## Urban Design Peer Review

# 716 Gordon Street Guelph, ON

Project: \_\_\_\_\_  
716 Gordon Street, Guelph -  
Official Plan Amendment and  
Zoning By-Law Amendment

Figure 2. Height and massing analysis

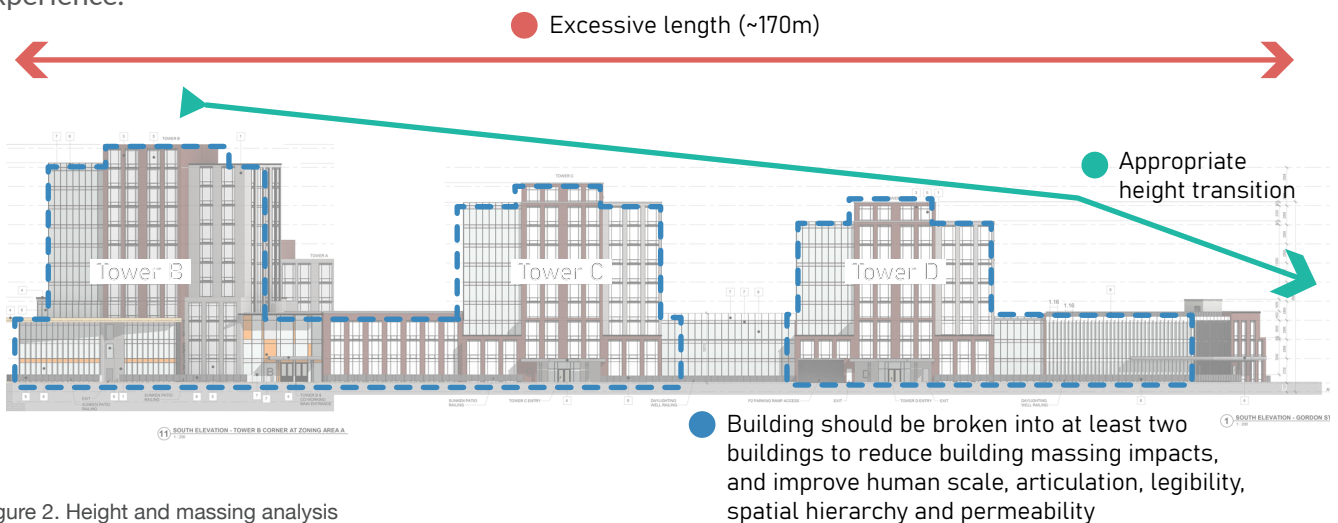
The overall building height is appropriate to the site's location allowing for intensification while responding to its surrounding context. The height is dispersed appropriately on the site by locating the taller elements closer to the corner and then stepping down to the residential area. The height transition from 12 to 8 storeys, and from 12 to 6 storeys, responds appropriately to the context, particularly due to the substantial setbacks from the eastern and southern property lines, adjacent to lower-scale buildings.

The massing consists of a 3-storey podium surrounding the site and four towers of different heights. The 3-storey podium height generally promotes a human scale, mitigates impacts of height and density, and reflects the adjacent lower-scale residential uses. However, the length of the proposed podium (~95m along Stone Road East and ~170m along Gordon Street), undermines its positive contributions and negatively impacts the human scale and pedestrian experience, creates an overwhelming massing that suggests an overbuild of the site, and does not reflect the established scale or rhythm of adjacent uses (see Figure 2). Breaking the massing into at least two different buildings would help mitigate density impacts, provide better site legibility, and improve permeability and the overall pedestrian experience.

Above the podium, multiple towers offer varying forms within the skyline and are generally well-massed and located to reflect an appropriate tower separation. Towers A and B are well-stepped back, clearly delineating between the podium and tower. However, Towers C and D are generally aligned to the main podium along Gordon Street resulting in an unclear delineation of building forms. This is further exacerbated by a podium design and articulation that does not quite align with the towers above. Towers C and D should be further stepped back to clearly distinguish between the building's podium and towers and improve the site's legibility and human scale.

At the corner of Stone Road East and Gordon Street, the massing is well articulated at the podium levels by introducing elements such as the extended canopy that surrounds and frames that entire section of the podium emphasizing the corner. However, the design of the tower itself would benefit from a similar siting, massing, and architectural treatment that frames, addresses, and visually connects both streets at the intersection.

Figure 3. Internal Programming analysis - Ground Floor

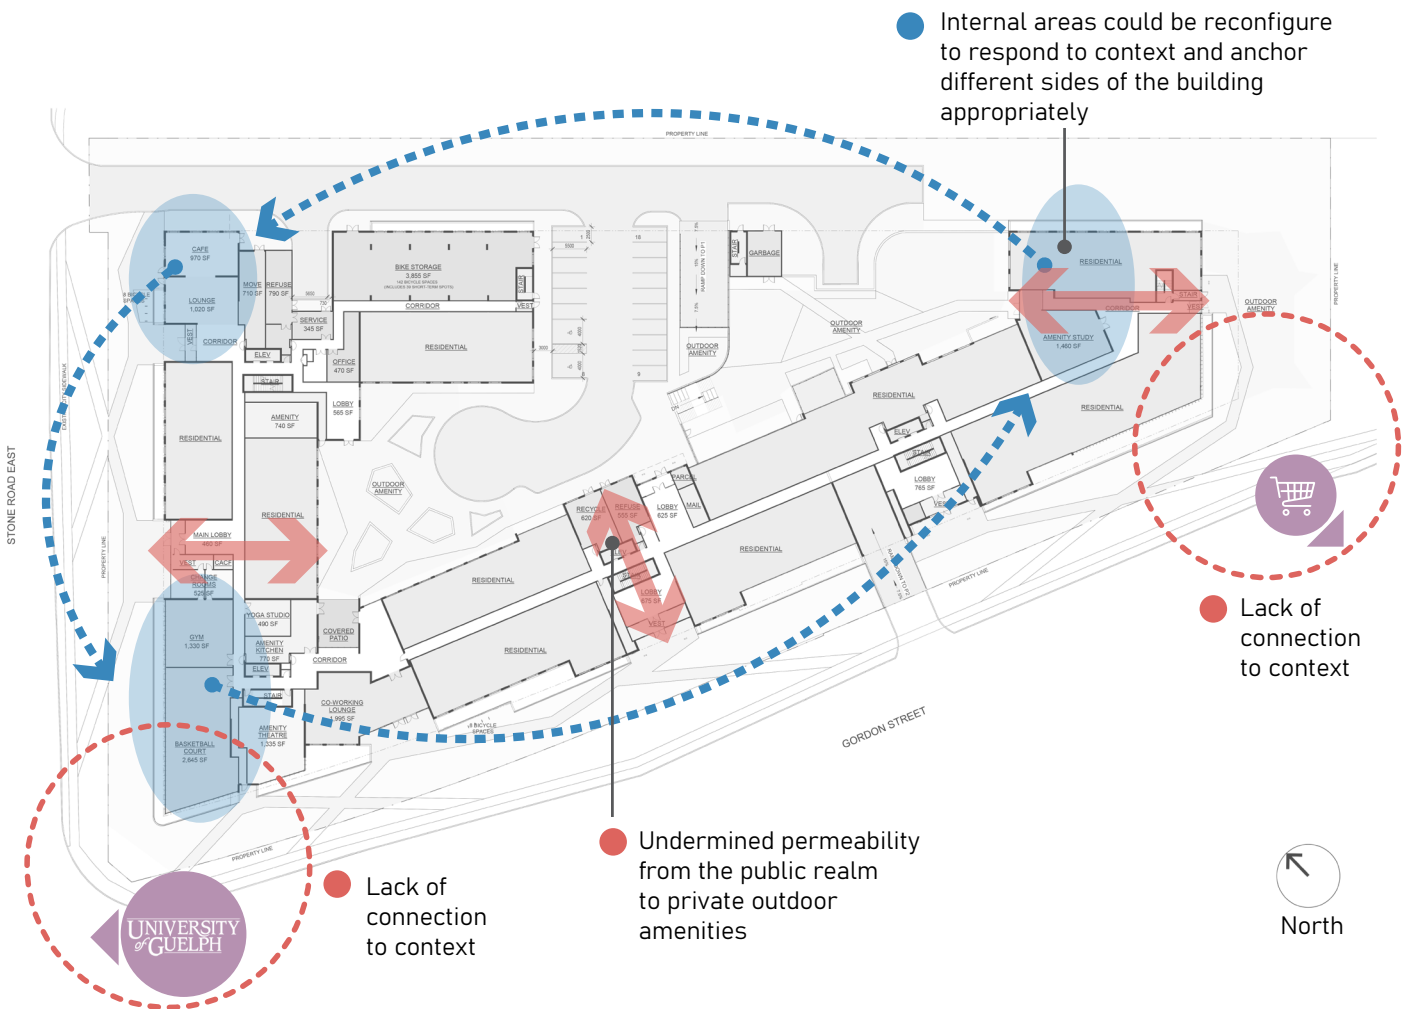
On the ground level, some of the amenity uses do not respond to the adjacent open space and land use context (see Figure 3). The development locates its more active and public use (i.e. a café) closer to the adjacent residential uses to the northeast, while the more private sports amenities are located at the corner of Gordon Street and Stone Road East, which should be the primary 'public face' of the building. This 'private' character is further exacerbated by the patio wells that are proposed to address the grade challenges on site.

The corner at Gordon Street and Stone Road East should reflect the more public and active use of the intersection and should relate to the park surrounding the iconic Gryphon Statue across the street. For this, the applicant should consider relocating other uses such as the café space to this area, as this could create a more vibrant and integrated corner (while the proposed basketball court would better serve as a transition to the 'back-of-house' uses and adjacent residential neighbourhood).

The south end of the development is mostly residential with one small entrance from the outdoor amenity space to the south on the ground level, one entrance from the central outdoor amenity space, and one amenity study area per floor from P1 to Level 3. The south end wing of the building has however greater potential to become an internal point of attraction and to better respond to the surrounding context. This side of the building would be of great importance as it is the closest to the shopping plaza across the street, and its design should respond to this functionality and reflect a sense of arrival. The applicant could consider reconfiguring this side of the building to include a greater vestibule, and some other amenity uses such as the gym and basketball court, which are of private use but can anchor that side of the building and provide better legibility, spatial hierarchy, and activity. Some of the residential units on this side of the building could be relocated to the northeast corner, adjacent to the established residential area, where the café space is currently located to provide for a better and more buffered transition to the active uses that are part of this development (see Figure 3).

● Internal areas could be reconfigure to respond to context and anchor different sides of the building appropriately

● Lack of connection to context

● Undermined permeability from the public realm to private outdoor amenities

● Lack of connection to context

Figure 4. Internal Programming analysis - 4th Floor

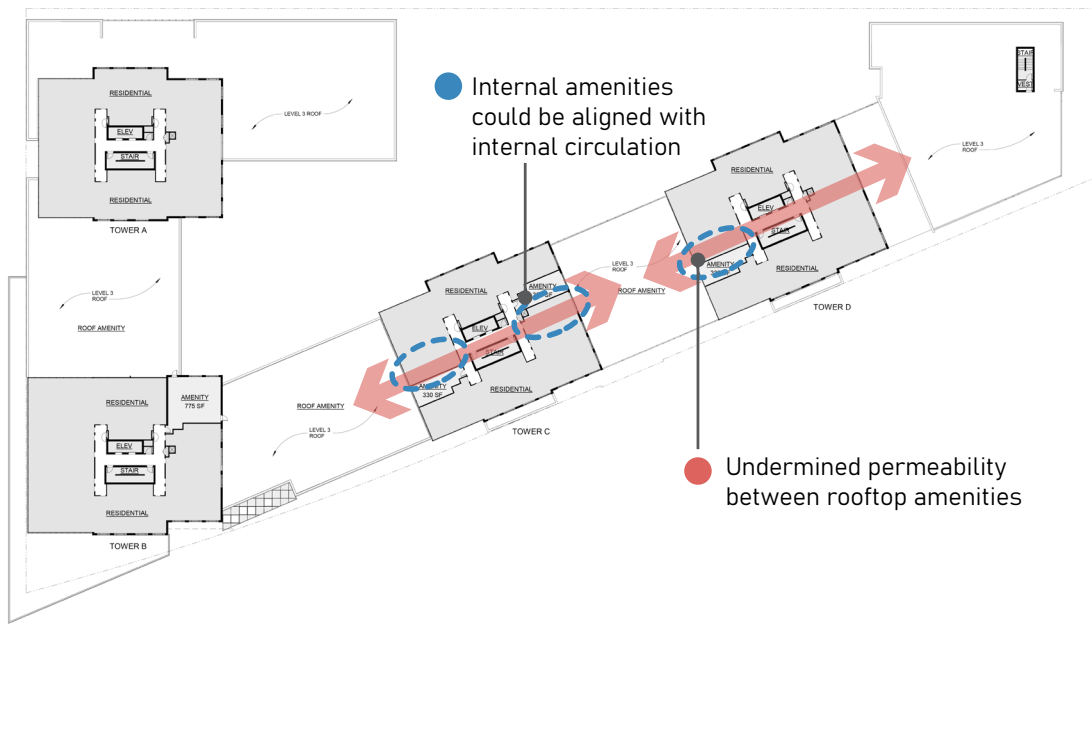
On the upper levels, the internal programming would also benefit from the consolidation and alignment of vertical and horizontal circulation. On Level 4, for instance, the proposed internal amenity spaces should be aligned with the internal corridor and provide a more integrated, visual, and direct connection between the different rooftop amenity areas (see Figure 4). The staircase and elevator areas could be better aligned to allow for vertical directness between some amenities and for a better connection between the public realm and the private outdoor amenity spaces on the ground floor.

Figure 5. Parking, access and loading analysis - Ground Floor

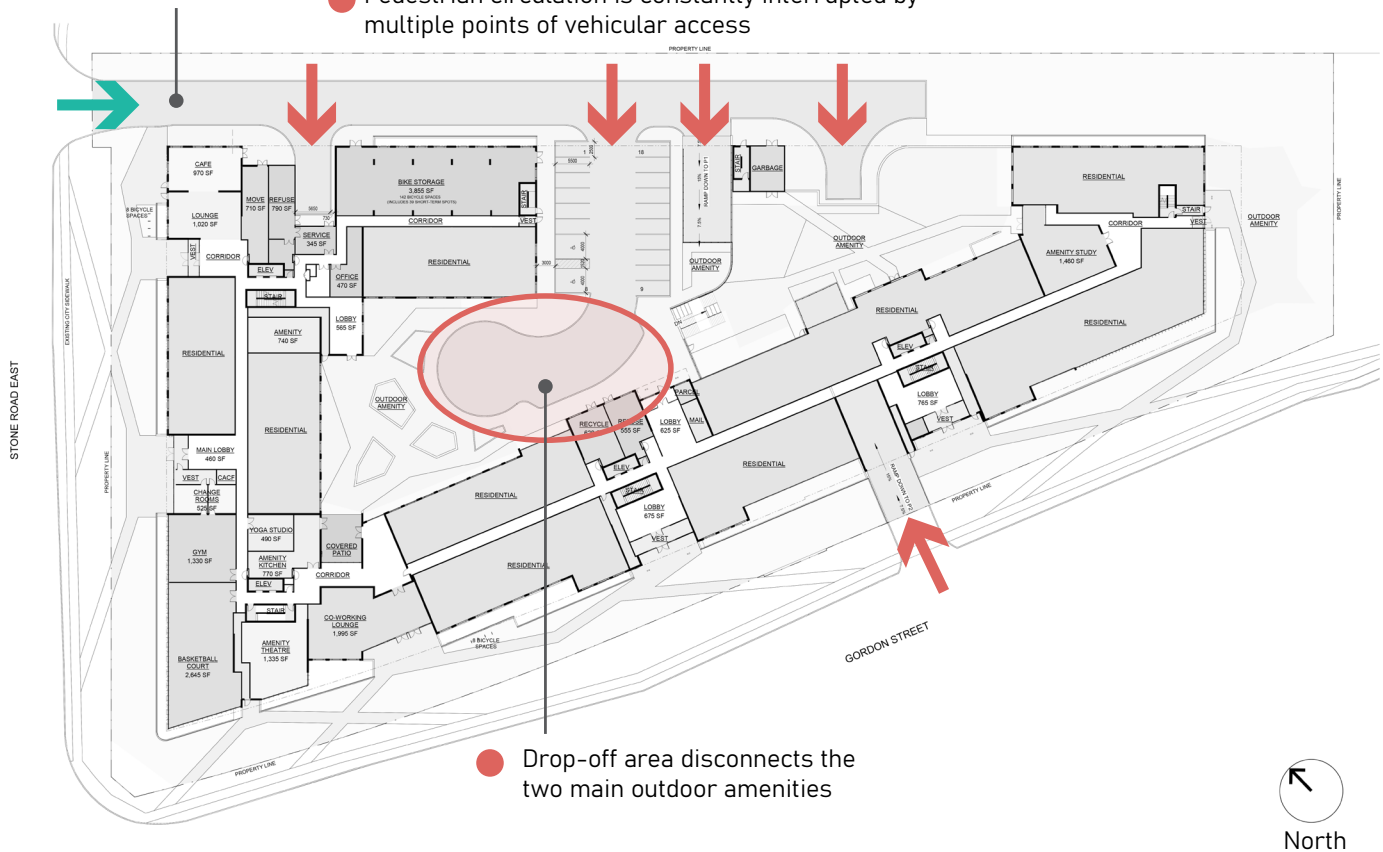
do not appear to be connected internally and even though most of the parking, access, and loading is at the rear of the building, it is not consolidated and requires multiple points of access which constantly interrupts the pedestrian circulation (see Figure 5). This could be due to the over-programming of the site and breaking the development into at least two buildings should help create additional opportunities to consolidate parking, access, and loading facilities.

● Most of the parking and loading services are appropriately located at the rear of the site

● Pedestrian circulation is constantly interrupted by multiple points of vehicular access

● Drop-off area disconnects the two main outdoor amenities

It would be ideal to consolidate street access at the rear of the site (i.e. remove the access from Gordon Street), consolidate internal parking, loading, and service access, consolidate most of the parking and services facilities underground, and have levels P1 and P2 connected internally.

Figure 7. Common amenity areas and open spaces analysis

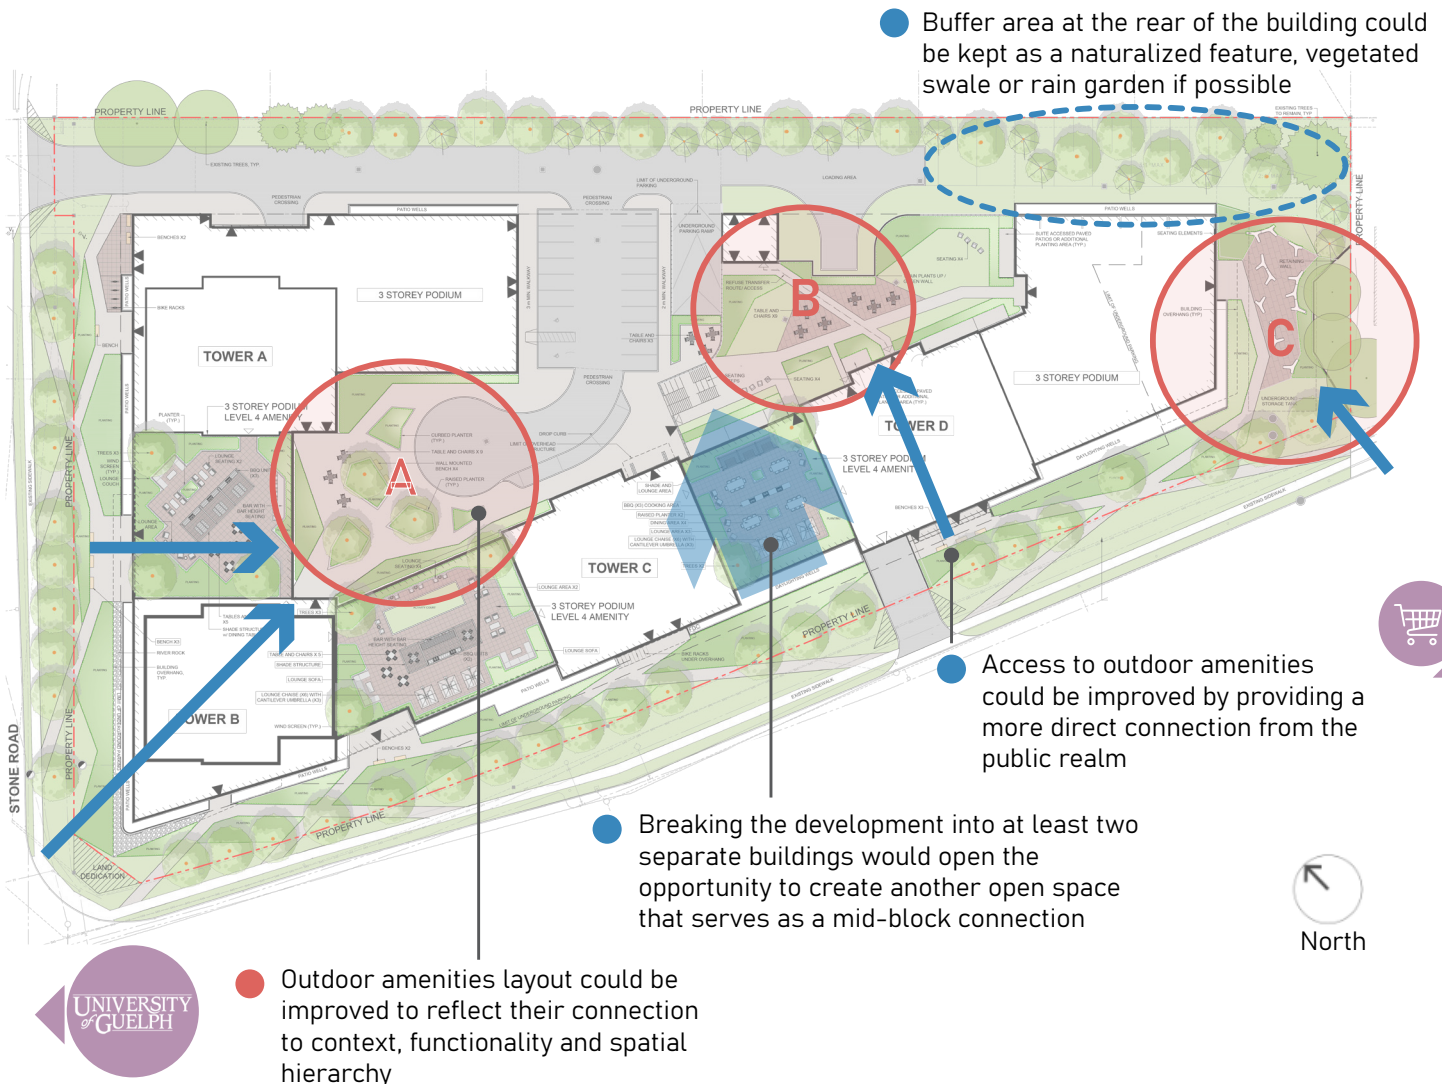
Outdoor amenity A (see Figure 7) is the largest, most enclosed, and central outdoor amenity in the open space hierarchy and is mostly surrounded by residential areas that will provide casual surveillance and consistent use.

The landscape design of the area, however, is currently designed to be more visually attractive rather than to functionally reflect its character as the primary outdoor plaza space. The applicant should consider making the planters smaller, remove the wall-mounted benches, and replacing them with additional (and more flexible) bistro seating with attached umbrellas. The applicant should also consider adding lighting, garbage bins, and outlets to the raised planters. This, along with making the drop-off into a pedestrian-priority area, could transform the area into an attractive flexible open space.

Outdoor amenity B (see Figure 7) is partially open and partially enclosed, and is on a lower level than outdoor amenity A. These characteristics make it an ideal space for a more relaxed and private environment, juxtaposing and complementing outdoor amenity A. However, the proposed landscape design currently reads as an extension of outdoor amenity A (see Figure 6).

At the south end of the subject site, outdoor amenity C (see Figure 7) offers a buffer to the neighbouring lower-scale building and features a combination of hardscape and softscape elements. The area will be very transited and of great importance for the students as it is the closest outdoor space to the shopping plaza across the street and other nearby retail areas. The current layout does not reflect this key functionality and character, which may impact its use and attractiveness. The landscape design should respond to the surrounding context and offer a more direct path from the building entrance toward the direction of the nearby retail areas. In addition, the applicant could consider adding bistro tables, garbage bins, lighting, bike racks, and seating places with electrical outlets for the students to work, and lounge. To the east of the hardscape area, it would be beneficial to include additional trees, especially coniferous trees, and hedging to reduce northern winter winds.

Figure 8. Facade design and articulation analysis - Front Elevation facing Gordon Street- Part I

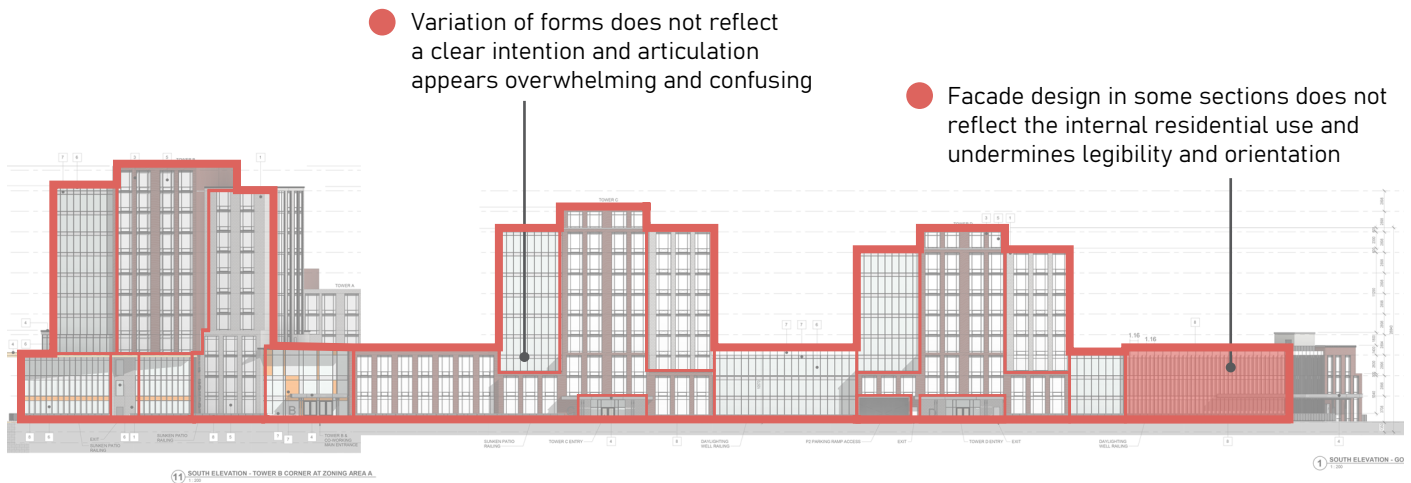
The facades show significant efforts to visually break the development into distinct-looking buildings linked by a common podium. The facades are highly articulated through recesses and projections, changes of materials, and colours to provide variation and interest. However, the variation of forms does not reflect a clear intention behind the design, and the articulation appears overwhelming and confusing, some of the facades do not reflect their internal uses and the overall architectural design seems disorganized and heavy (see Figure 8).

Ideally, there would be a clean break between the different buildings (on the elevations), which could be accommodated, for instance, by using brick for the building podiums and clear glazing for the adjoining sections (see section 11).

Figure 9. Facade design and articulation analysis - Render showing the corner at Gordon Street and Stone Road East

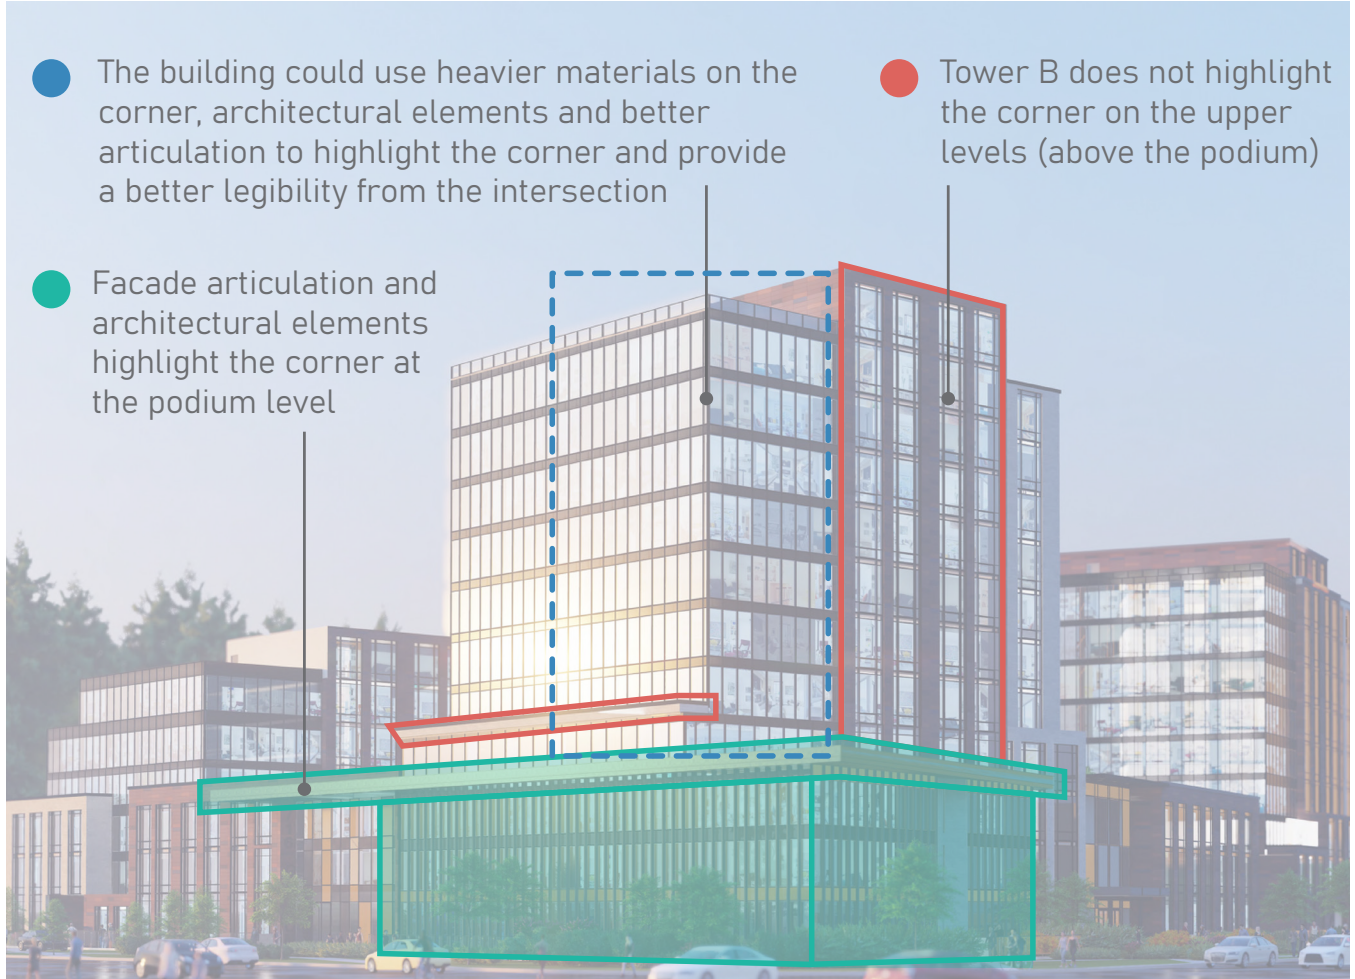
At the corner of Stone Road East and Gordon Street, the podium is well set back with substantial protruding elements that give the appearance of a step back above the podium accentuating the corner (see Figure 9). However, Tower B itself could use some articulation and 'heavier' materials (i.e. stone, brick) that continue highlighting the corner vertically within the tower. This could help in defining a hierarchy of forms along the Gordon Street façade, enhancing legibility and visual attractiveness at the corner.
